Concerning: 1220 Iron SW

DESCRIPTION OF REQUEST: Application for Sketch Platt Review for 1220 Iron SW - Desire to Re-Platt Lot

PRE-APPLICATION REVIEW TEAM (PRT) MEETING

PA# 17-102 Date: 7/25/2017 Time: 2:30 PM

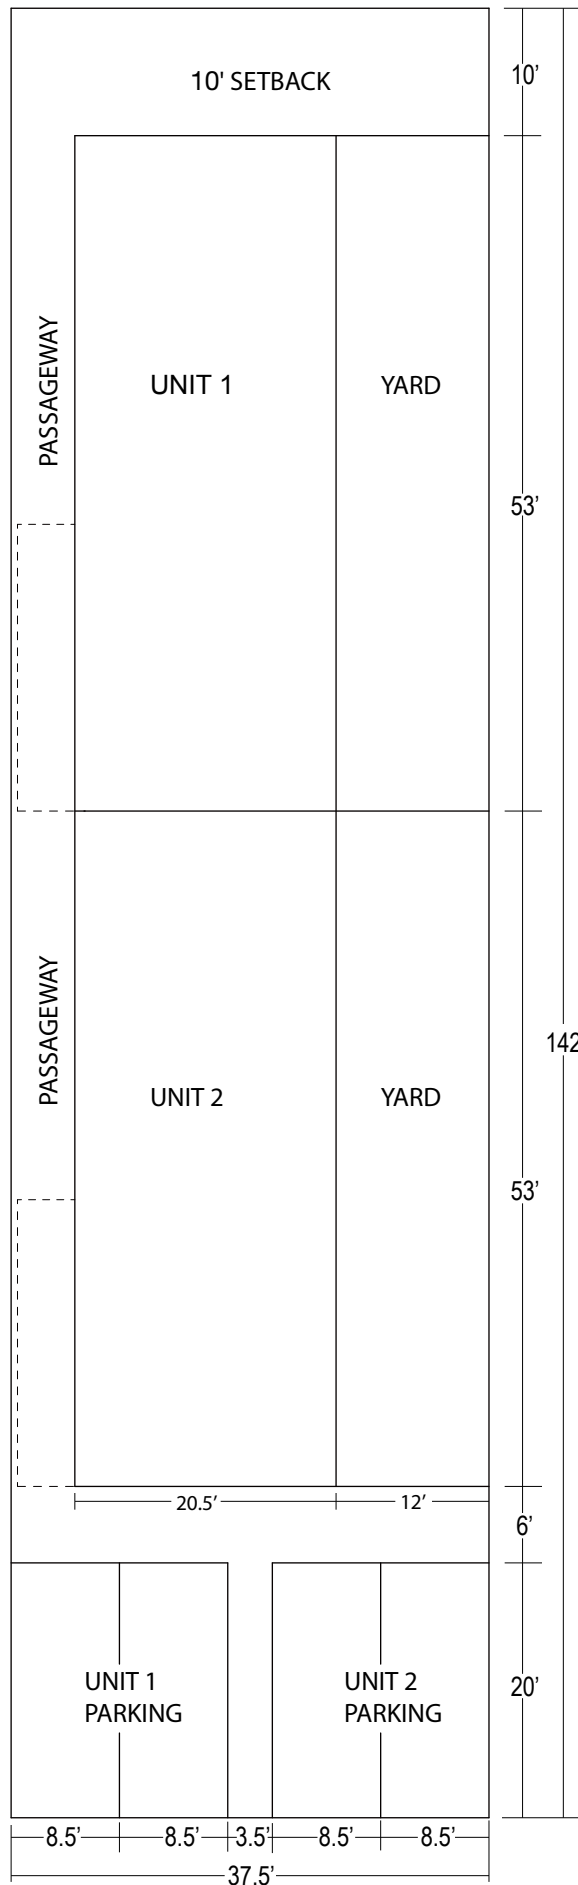
LOT SIZE = 37.5' WIDE 5,325 SF. - AGS SCAVES @ 25' WIDTH?
(25' x 142.37') AGS

ALLEY IN REAR.

PER BAPELAS SDP. MIN LOT WIDTH W/ ACCESS FROM ST OR
ALLEY - MIN. LOT WIDTH = 25' LOT AREA 2500'±

SETBACKS = 10' FRONT.

IF PROPOSING TH (2) = 22' @ UNIT 2200'± EACH LOT SIZE.

MIN OFF ST. PARKING - 14.16.3.1 (1.5 or 2 @ UNIT - ASK VINCE.
USABLE OPEN SPACE PER 14.16.2.9 (G)
SETBACKS (EXCEPT MENTION IN BARELAS SDP) IS PER 14.16.2.9
(E)

NEED VARIANCE TO REQ'D LOT WIDTH OF 25' @ UNIT =
50' MIN WIDTH.

~~CODE BOOK~~ LOT WIDTH - 37.5' (PER PLAT) - ^{MIN 26'} (18' @ UNIT)
LOT WIDTH.

WANTS TO PUT 2 TH ON A SINGLE LOT.

SECTION. 14.16.2.9 (P.T) (DX2) ... FOR A TOWNHOUSE W/
VEHICLE ACCESS...

MUST HAVE 10' SEPARATION BETWEEN ADJACENT
BUILDINGS (EXISTING)

FRONT SETBACK PER BARELAS SDP - 10'

PG 71 - SU. 2/P.T EXCEPTIONS WHICH APPLY TO
HOUSE (25' / 2500 SF)

PARKING BACKING UP ON ALLEY. 8.5' x 20' PARKING
SPACES.

DEVELOP CURB CUT. WHICH PROVIDES ACCESS. MUST
REMOVE TO MEET REQ'MENTS OF PROPOSED
DESIGN.

CAN NOT BUILD OVER LOT LINE - REPLAT AS A
MINOR PLAT ACTION, IF THAT'S THE CASE. SURVEYOR.
DRB. SKETCH PLAT THRU. CAN DO A LOT SPLIT TO
CREATE TWO SEPARATE LOTS FOR OWNERSHIP.
